CITY PLAN COMMISSION STAFF REPORT

Metro North Crossing UR Plan

CD-CPC-2020-00176 – Rezoning with plan

Report Date: April 01, 2021
Case Number: CD-CPC-2020-00176
Project: Metro North Crossing

SHEET 03

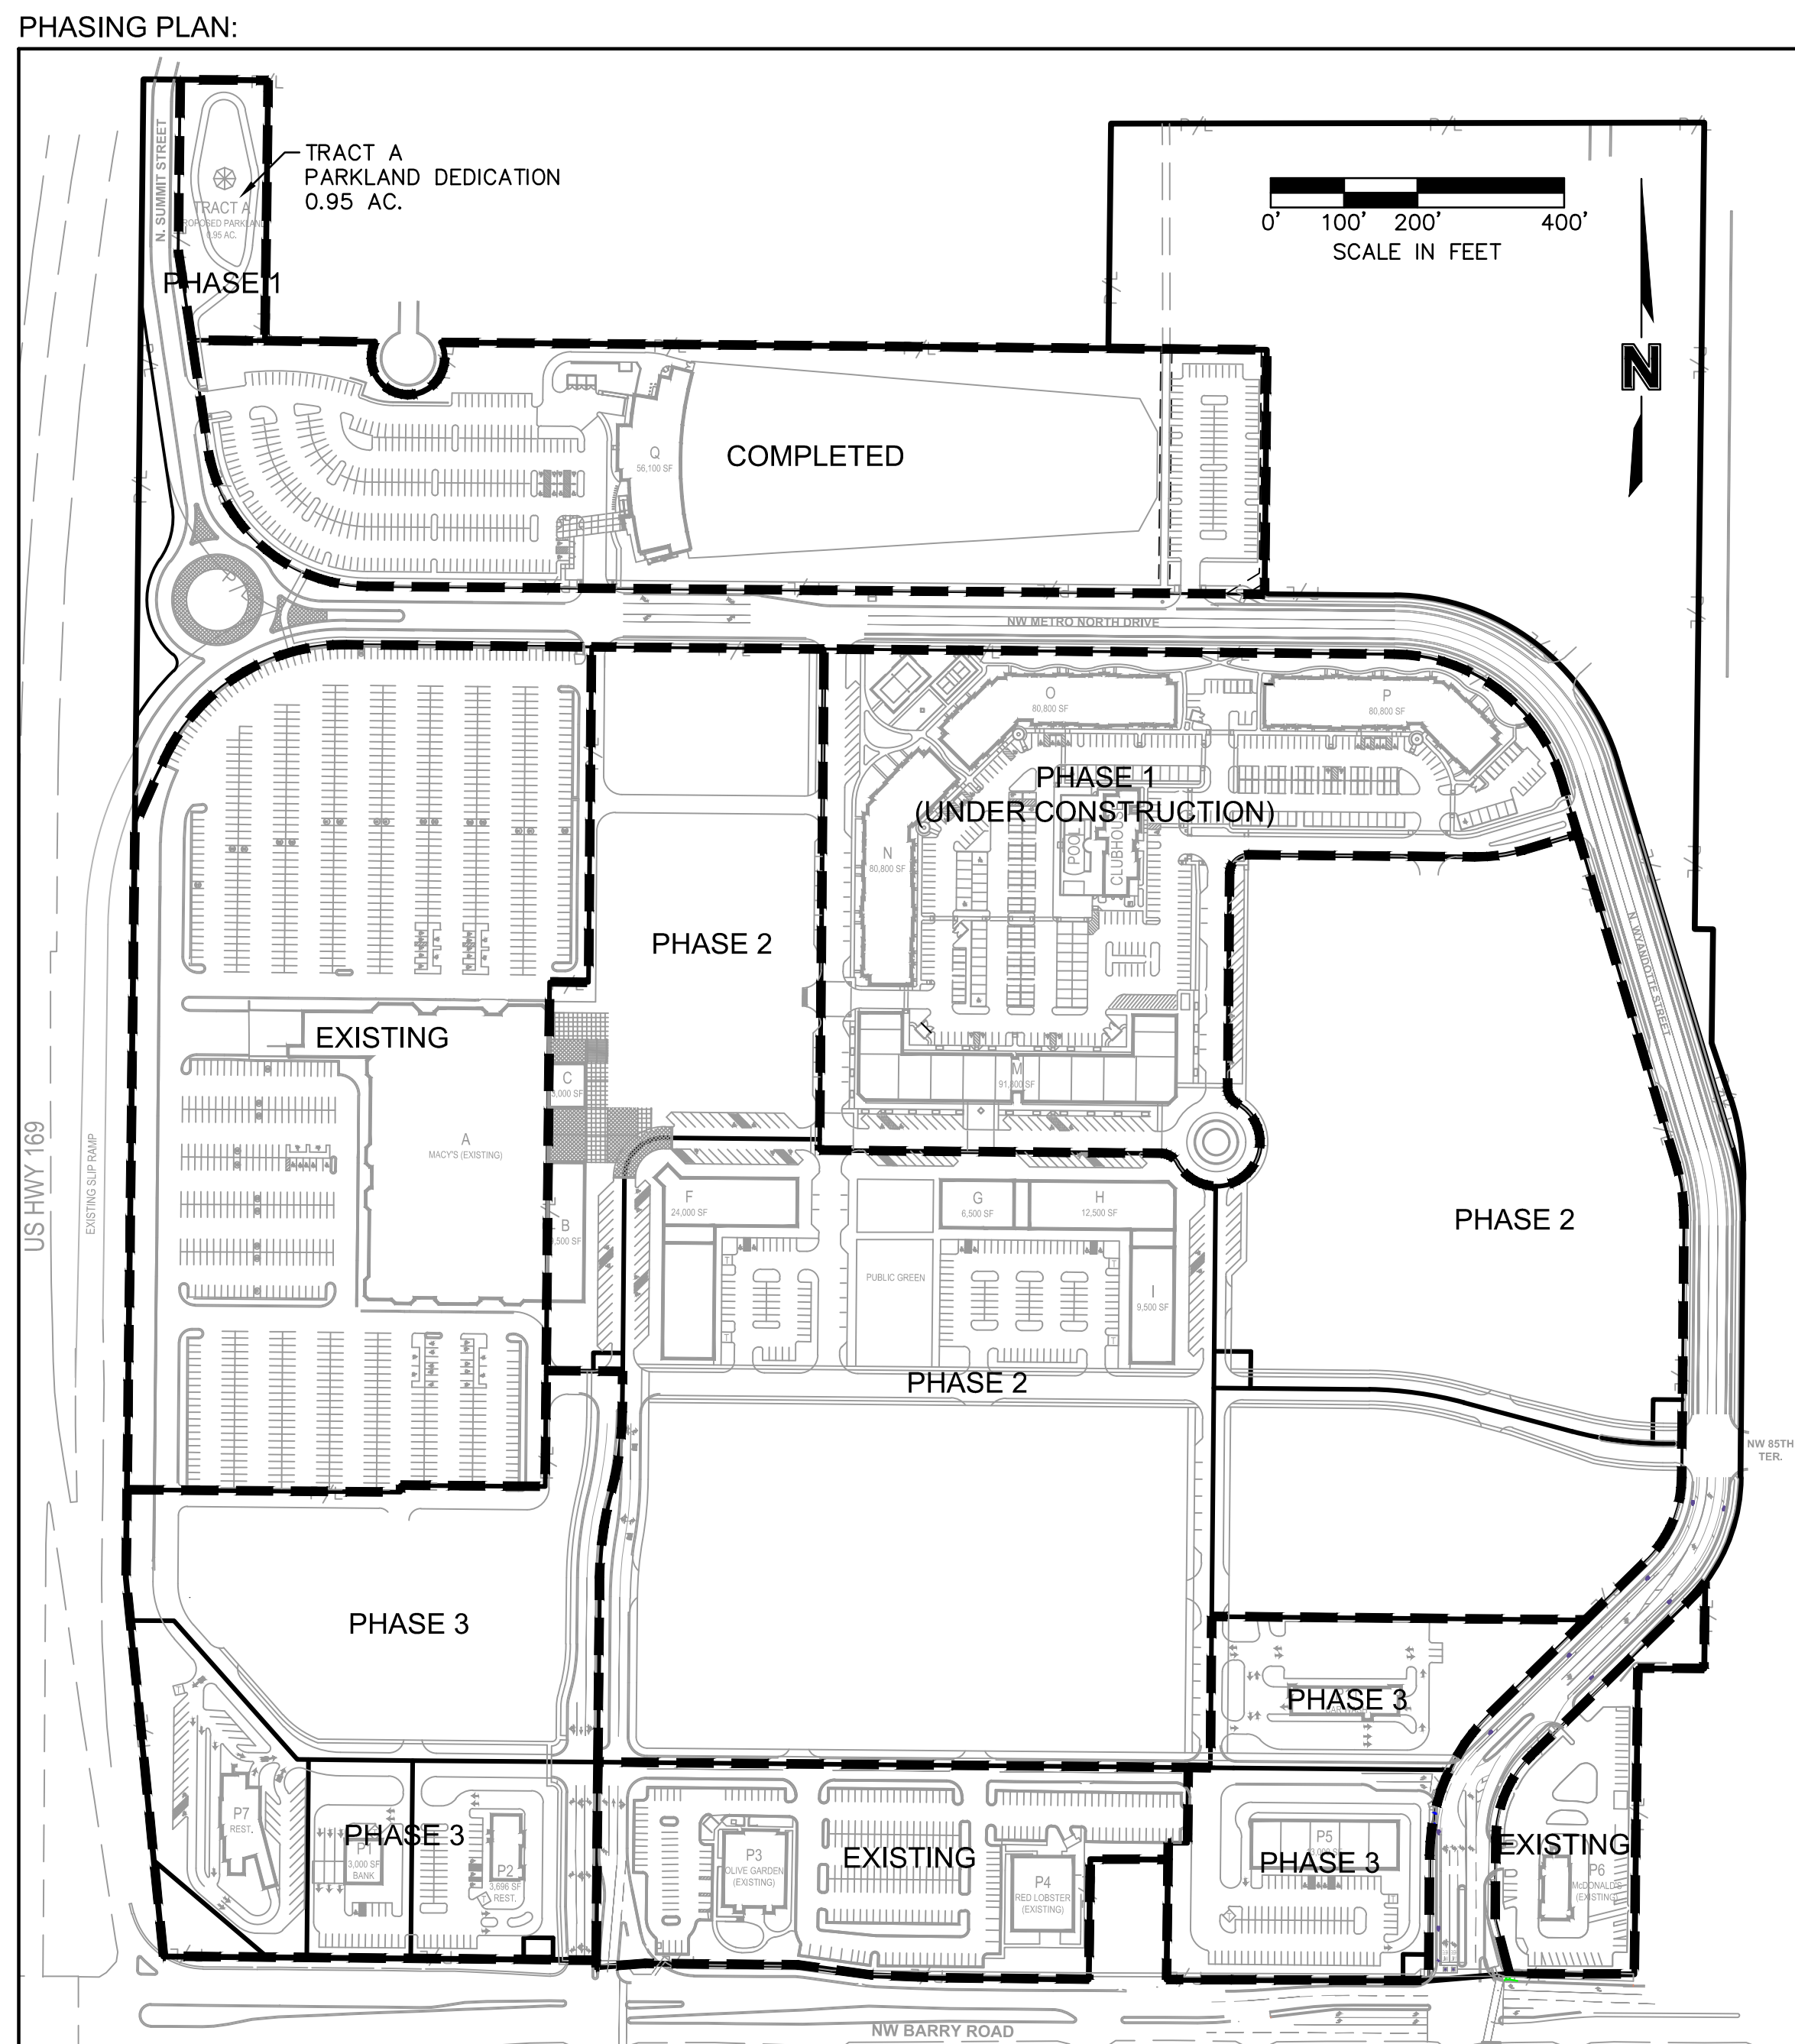
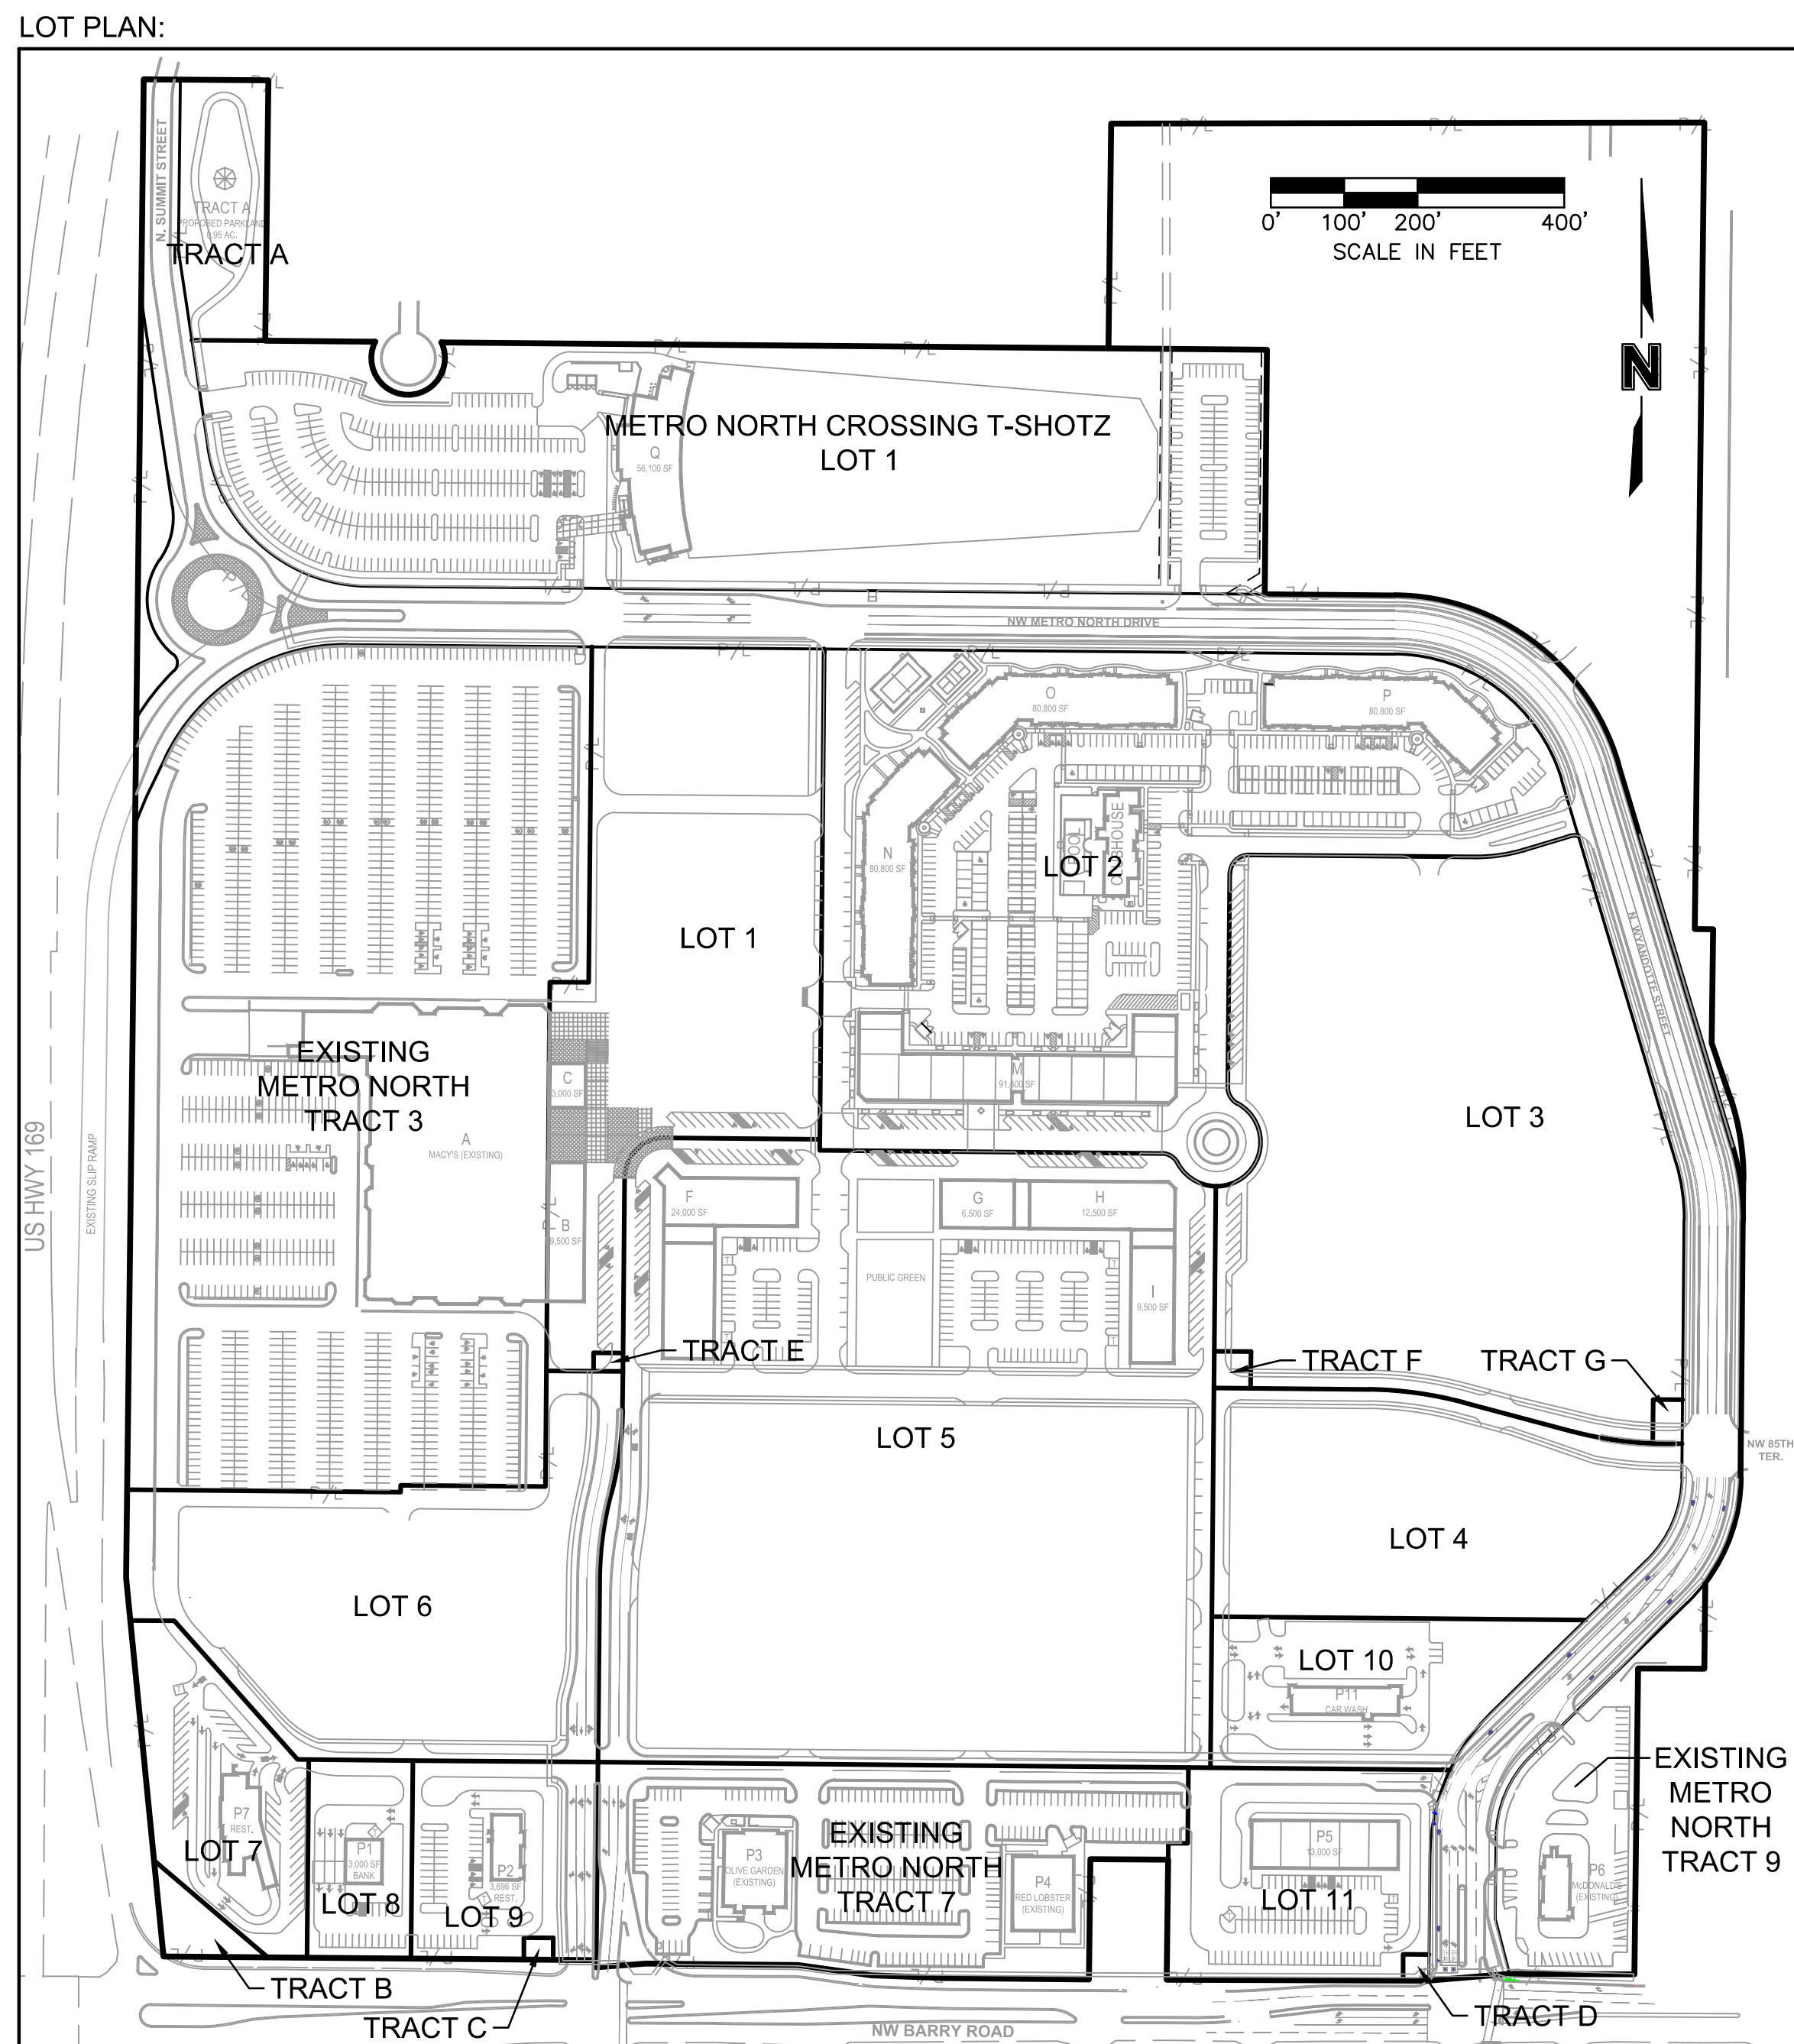
1. Revise phasing plan to reflect phase 2 as projects identified on this plan and phase 3 as future projects not shown on plan. Revise Plans and Resubmit (4/01/2021)

2. Put the public green in a tract and provide proposed programming of the dedicated public space. Revise Plans and Resubmit (4/01/2021)
3. Revise design standards to provide for minimum transparency requirements. Revise Plans and Resubmit (4/01/2021)

4. Proposed preliminary plat changes and possible replat. Show lots that are planned to be replatted via minor subdivision. Revise Plans and Resubmit (4/01/2021)

5. Renumber all lots per current approved plats and update proposed replat lot numbers to match. Revise Plans and Resubmit (4/01/2021)
6. Add language calling for additional landscape treatment and requirement along public streets. This language shall call out all outlots along NW Barry Road and N. Wyandotte Street. Revise Plans and Resubmit (4/01/2021)
